**October 13, 2021
7:00 PM
Planning Board Agenda**

Re: **Response to Lanc & Tully Comments dated 09/08/21 and John Clarke comments dated 09/09/21**
*248 Beacon Holdings LLC - Fishkill Creek Development Amended Site Plan for 248 Tioronda Avenue
(Formerly Beacon 248 Development, LLC, Multifamily Development)
248 Tioronda Avenue, City of Beacon, Dutchess County, NY
Chazen Project #81750.00*

Re: Supplemental Submission – Application for Amended Site Plan Approval
Modification to Approved Greenway Trail
Premises: 23-28 Creek Drive, Beacon, New York
Tax Parcel ID: (6054-37-037625)

4 ELEVATION - SOUTH 02
1/8" = 1'-0"

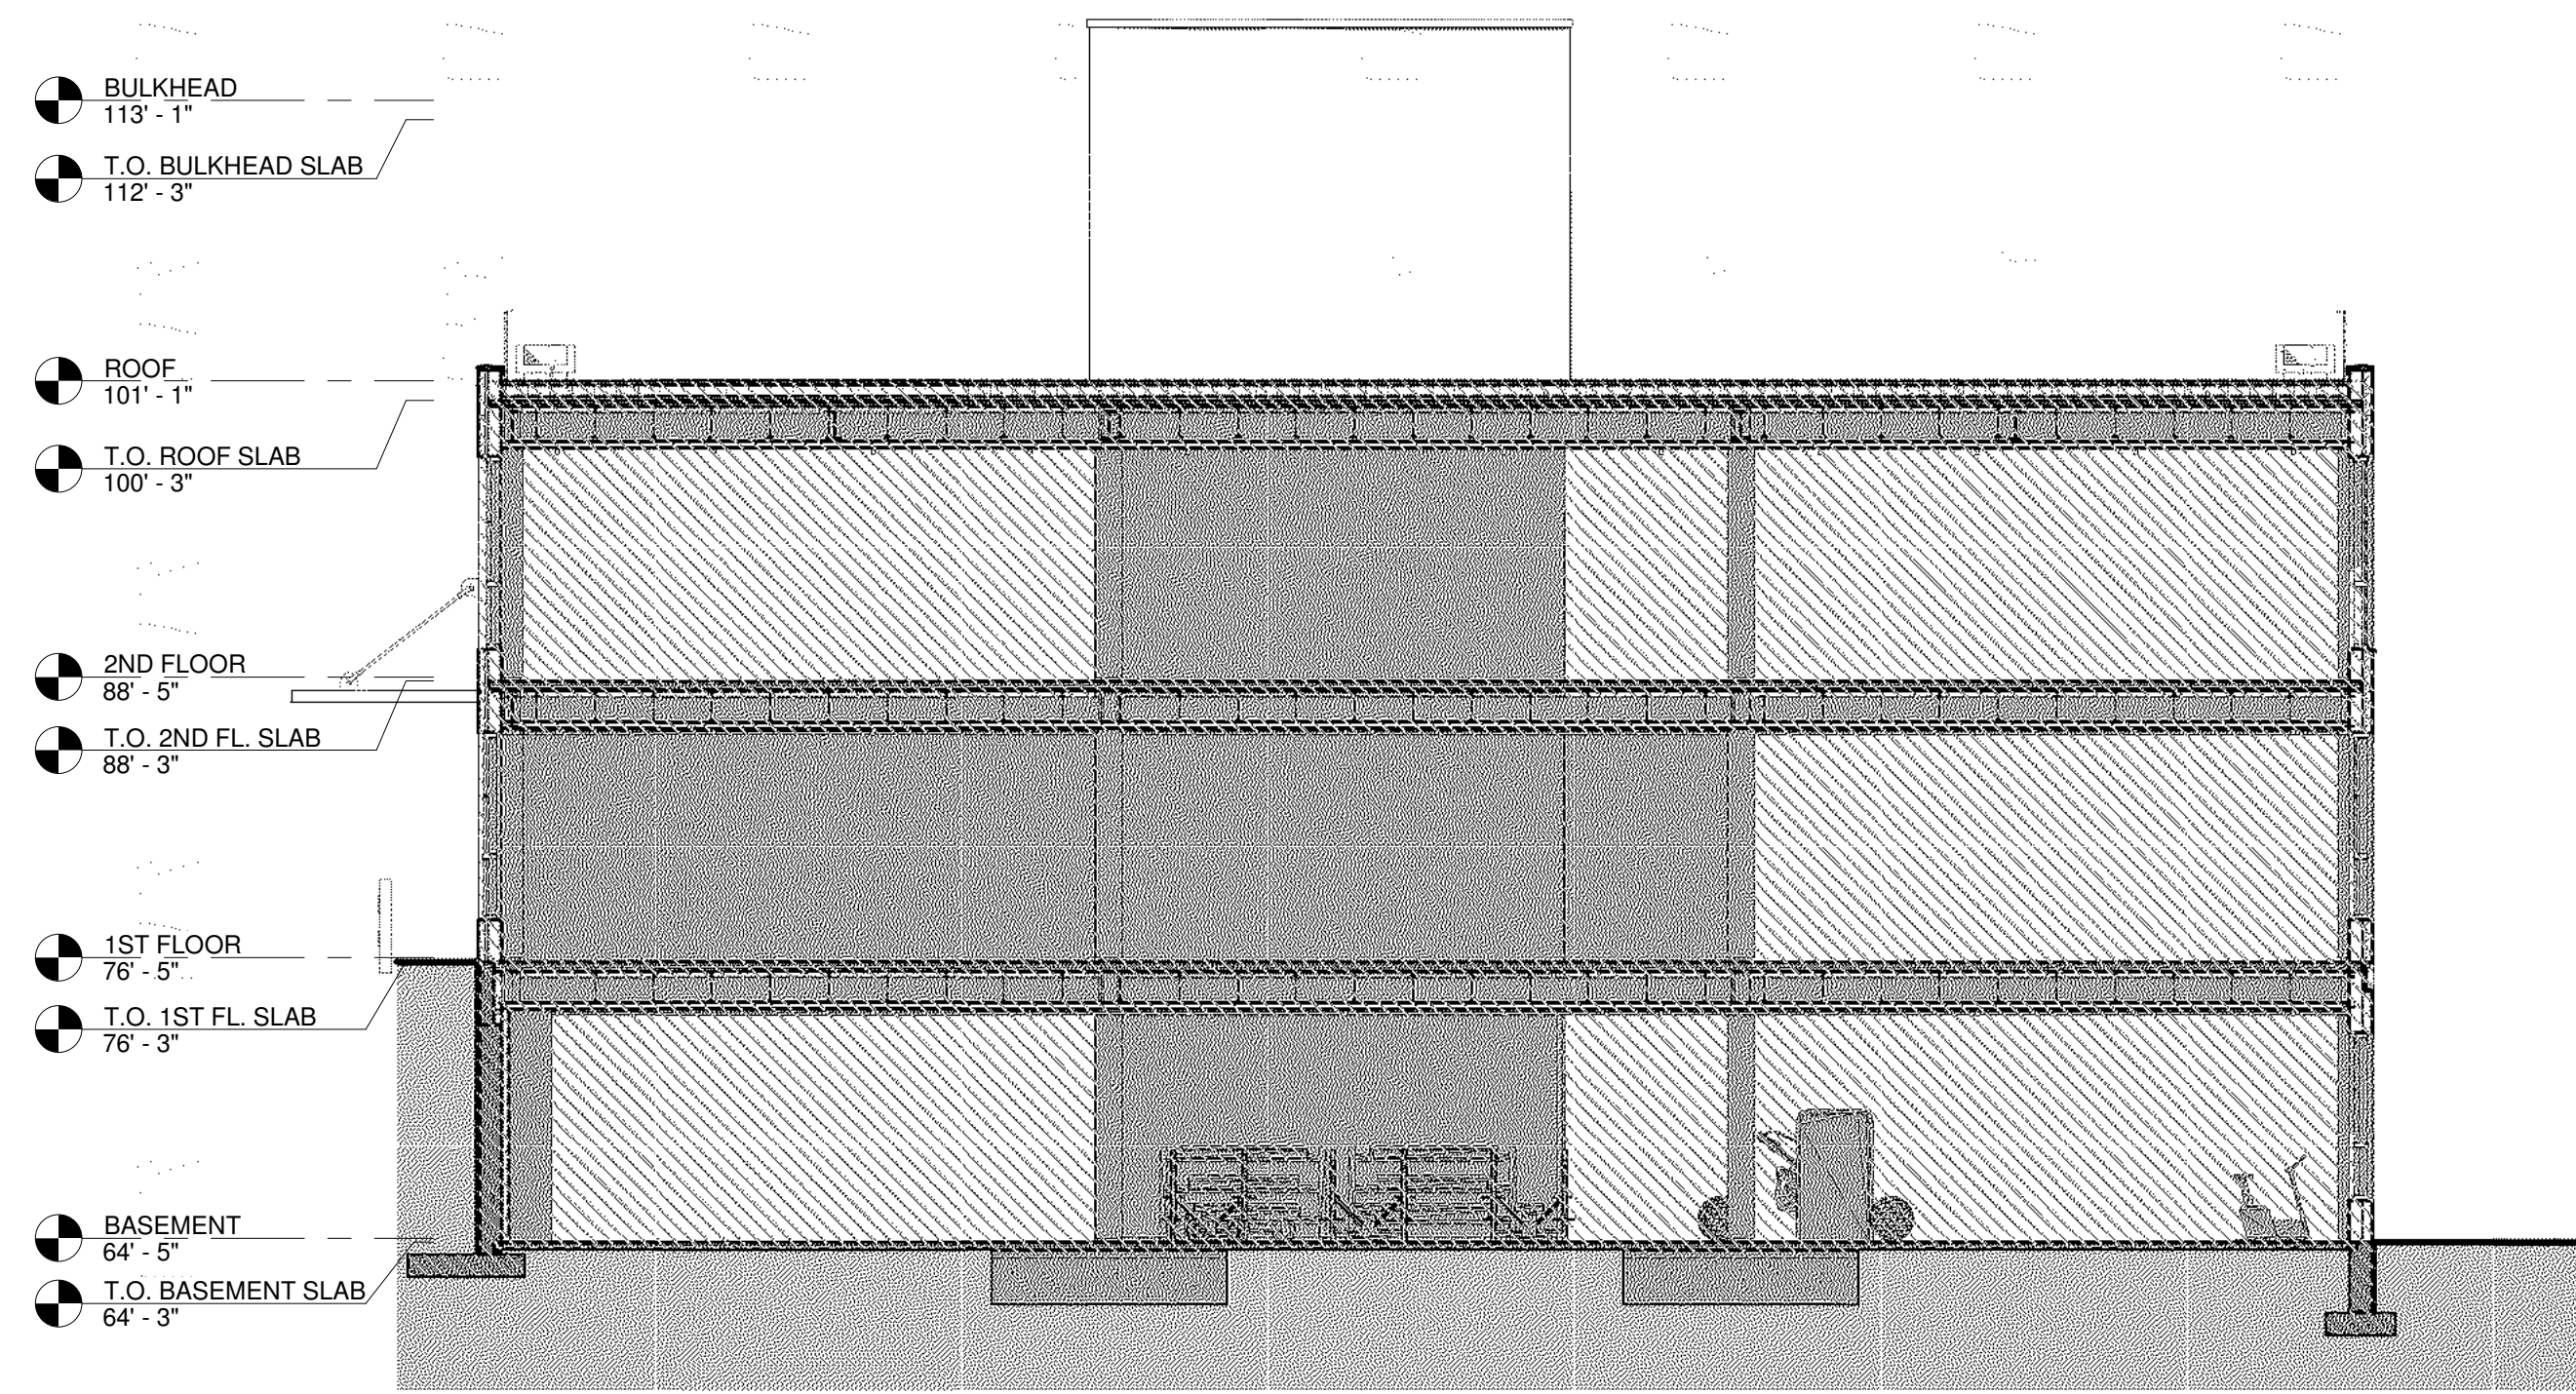
- c. The exterior materials and colors should be labeled on the elevation plans. The type of brick, thin or full-size, should be indicated, the roof railing should have a detail, and there should be a legend explaining all the material abbreviations.

Response: Material legend sheet and roof railing sheet shall be added to submission.

PARKING PLAN

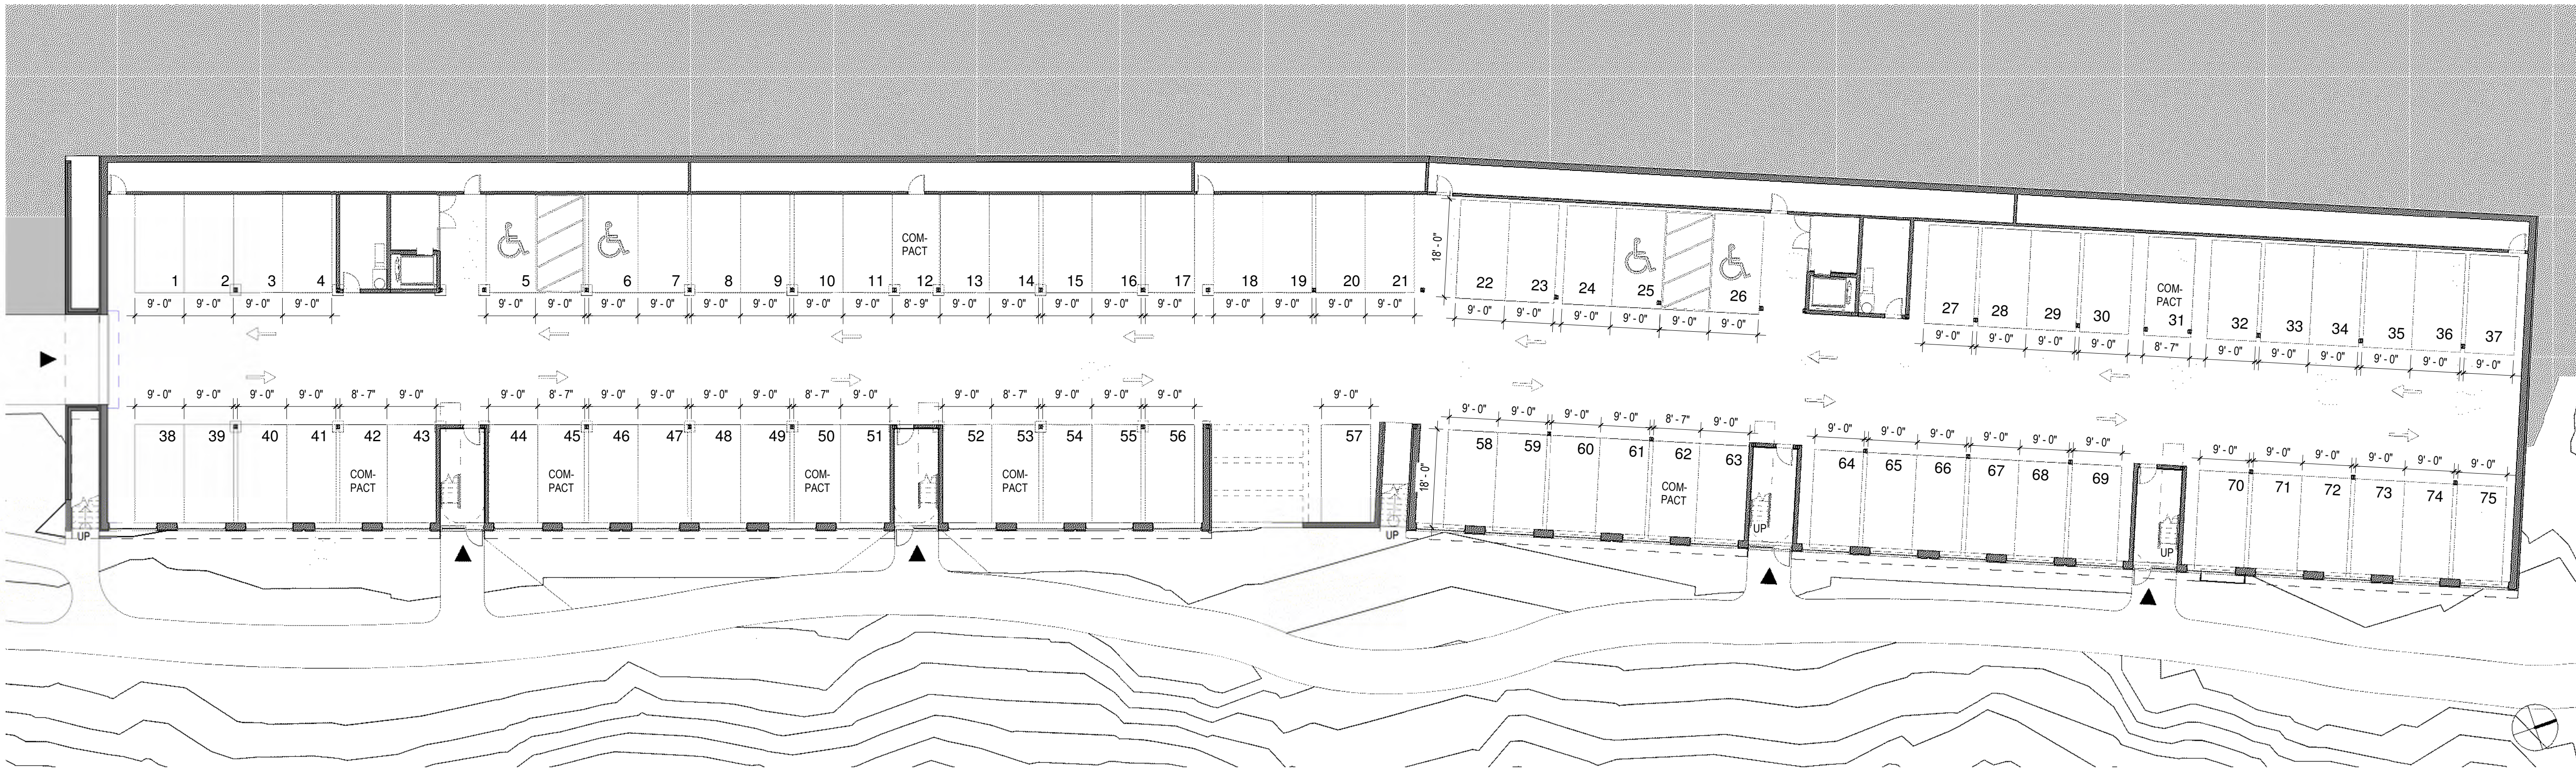
3. For the Buildings 200 and 300 Parking Plan, the response letter states that the requested changes from last month have been made, but the submitted Plan is the same as the August version:
- a. The ADA spaces should be located as close to the elevator doors as possible. It seems that ADA spaces 2 and 3 could be switched to spaces 4-6 and spaces 23-24 to 24-26.

Response: The previous version of the Building 200 and 300 Parking Plan was erroneously submitted. The revised version, which was shown at the August Planning Board changes the parking as suggested. ADA spaces 2 and 3 were switched to spaces 4 – 6 and spaces 23 – 24 to 24 – 26.

1 SITE PLAN
SCALE: 1"=30'

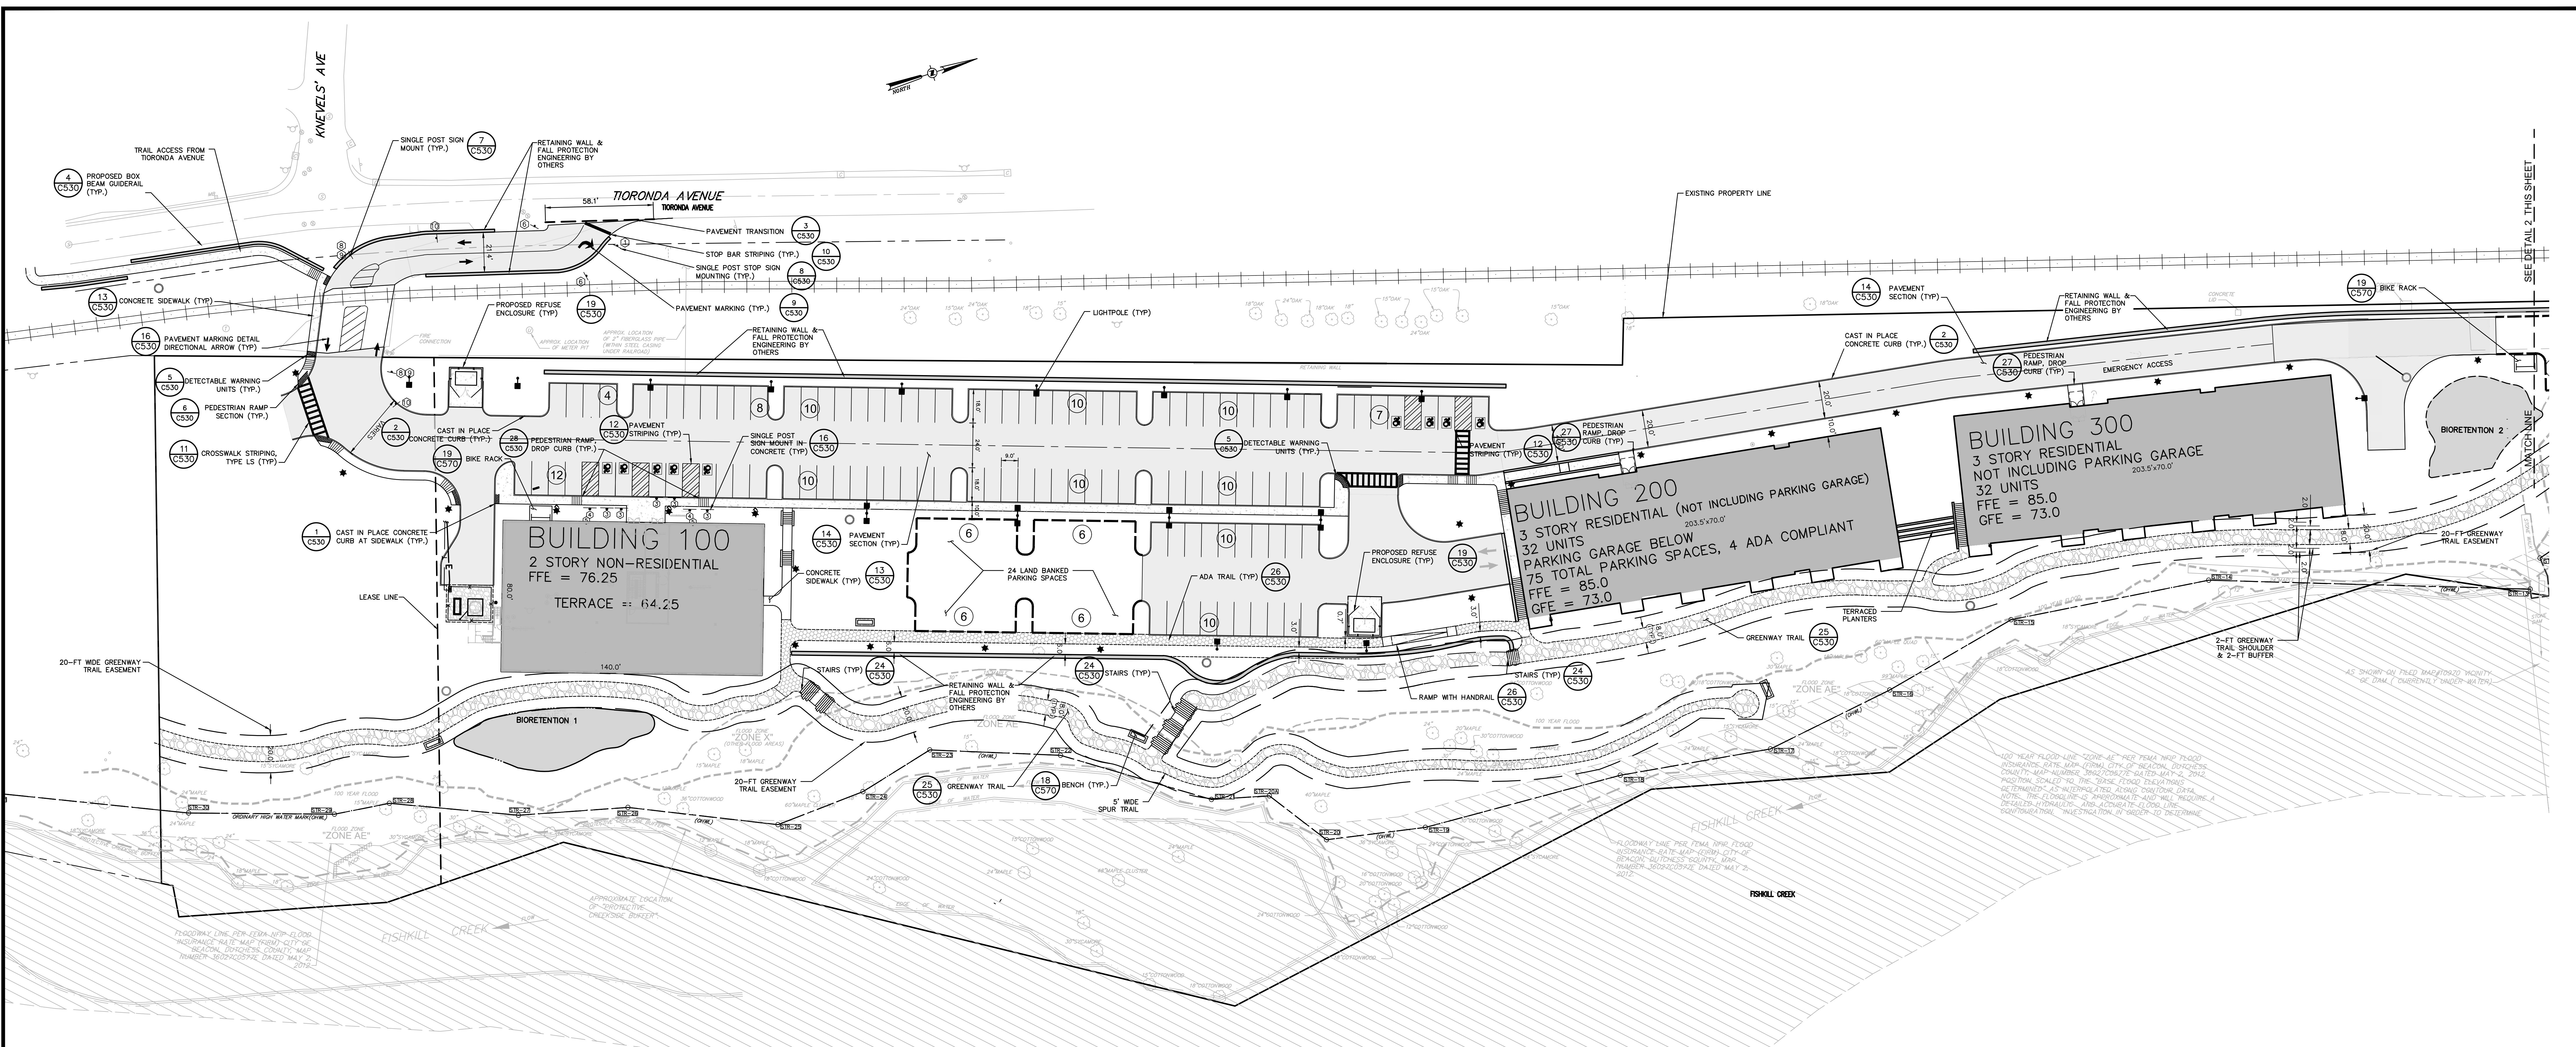
- b. The applicant has included a separate trail connecting up to Wolcott Avenue, but states that the slope would be greater than the maximum ADA requirement. The proposed slope should be indicated on the plans and the applicant should be prepared to explain whether an ADA-compliant connection is possible.

- c. The exterior stairs on the south side of Building 100 should be shown on the plans.

Response: ADA compliance is not possible without structures that would be not appropriate for a greenway trail. The Committee has communicated support for the trail as designed at approximately 7% slope.

Response: The exterior stairs on the south side of Building 100 are now shown on the plans.

1 LANDSCAPE PLAN
SCALE: 1"=30'

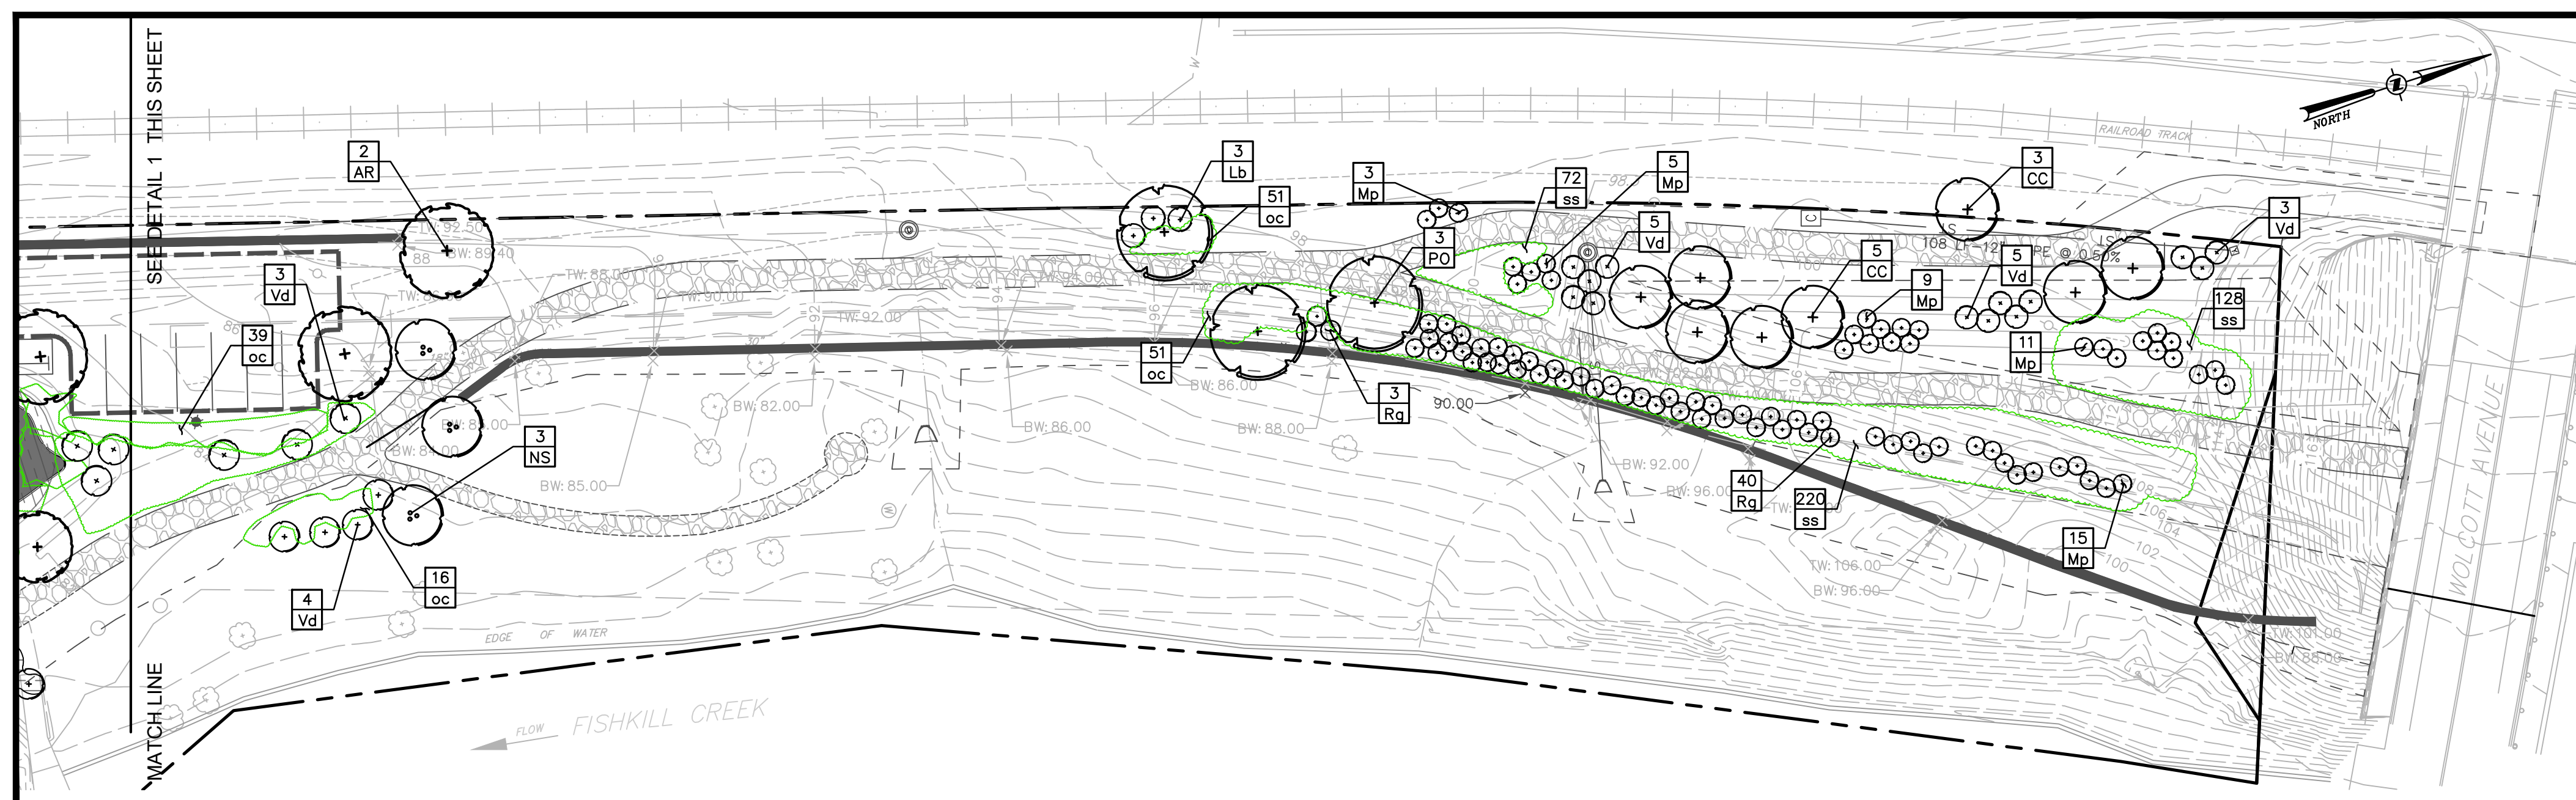
1. Two trees are proposed within 5 feet of the proposed sewer line on the sewer run between SMH-4 and SMH-3, near building 100. We would recommend that these trees be shifted closer to the trail running along the backside of the shadow parking lots so as not to impact the sewer lines during the planting of these trees or in the future.

2. For Sheet 9, the revised Landscape Plan shows about 20 additional trees to be planted north of the northern land-banked parking spaces. This is commendable. However, the City Council is considering the 600-foot section of Tioronda Avenue south of the Wolcott Avenue intersection, looking east and southeast towards the Highlands ridgeline, for a designated scenic view. The trees planted in this northern section should be selected to have a mature height below the elevations along Tioronda Avenue.

Response: The Landscape Plan has been revised to eliminate any conflicts with the sewer lines.

Response: The planting plan has been revised to substitute shrubs for the proposed trees to eliminate potential height conflicts with the possible designated scenic view at that location.
